The following changes in the tender documents are effective immediately. This addendum will form part of the contract documents.

END OF ADDENDUM No. 1

FRASER PORT OF ENTRY: PHASE 2 EXISTING SLAB DEMOLITION AND REPAVING

Drawing title/Titre du dessin
**SECONDARY INSPECTION CANOPY
DEMOLITION AND NEW WORK**

1 A-03 1:100
NEW ROOF PLAN

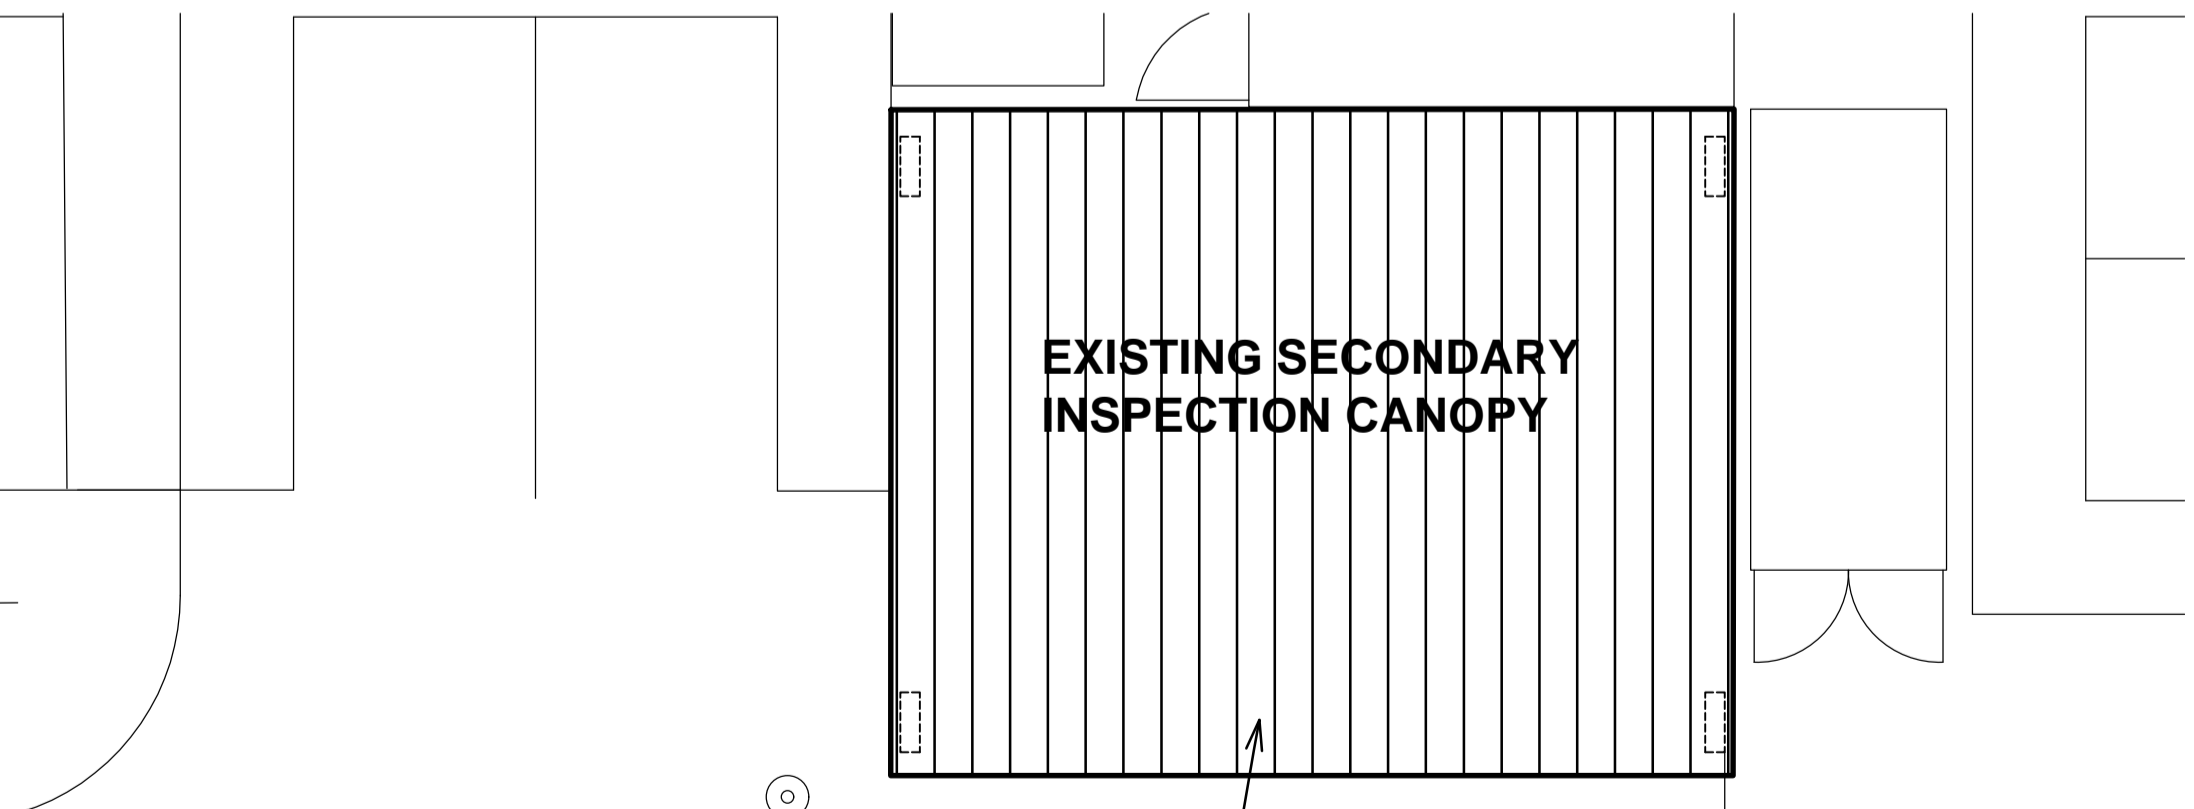
-DEMOLISH EXISTING STANDING SEAM ROOF.
TYPICAL NEW ROOF ASSEMBLY:
-NEW 19MM BCX TREATED TONGUE & GROOVE EXTERIOR GRADE PLYWOOD (PAINTED) - (FASTEN PLYWOOD WITH #10 SCREWS @ 152MM ON CENTRE AROUND THE PLYWOOD PERIMETER AND @305MM ON CENTRE INTERMEDIATE)
-NEW ROOF UNDERLAYMENT
-NEW STANDING SEAM METAL ROOF
